E5091A-01

S E R V I C E N O T E

E5091A Multiport Test Set

Correction to Maximum AC Power Consumption Label

Figure 1 Location of the label on the E5091A rear panel

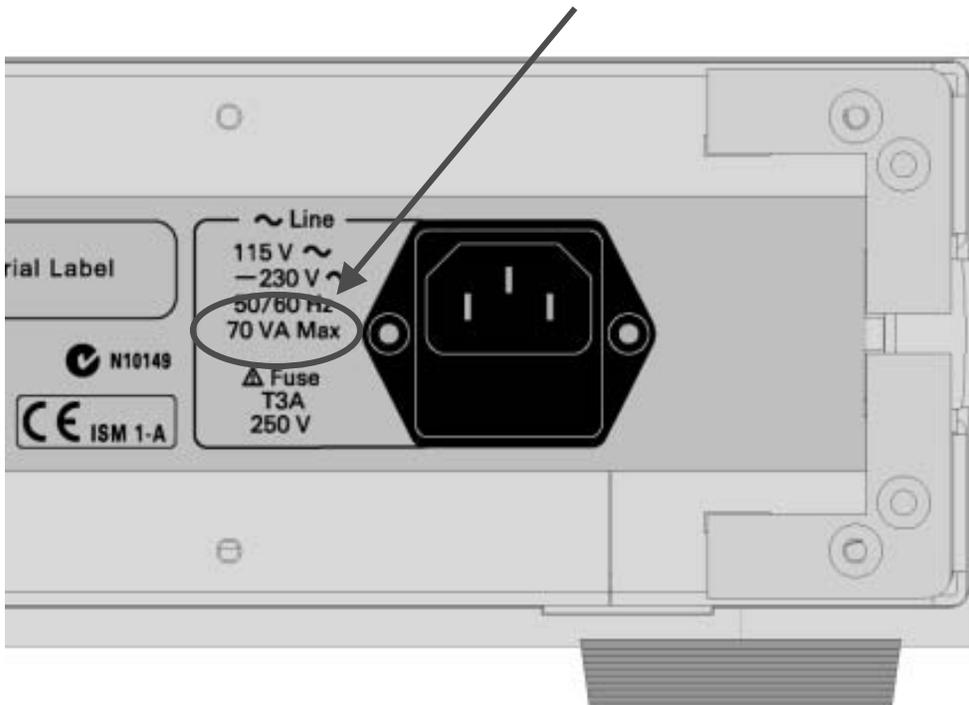
The maximum AC power consumption of the E5091A exceeds “70 VA Max” silkscreened at the AC power line inlet label on the instrument rear panel. The silkscreened power value must be corrected to read “150 VA Max”.

For the E5091A with serial numbers JP1KJ00142 and below, paste a label (P/N 5185-3769) of “150 VA Max” just on “70 VA Max” of the AC consumption power label. See Figure 1 for the location of the label.
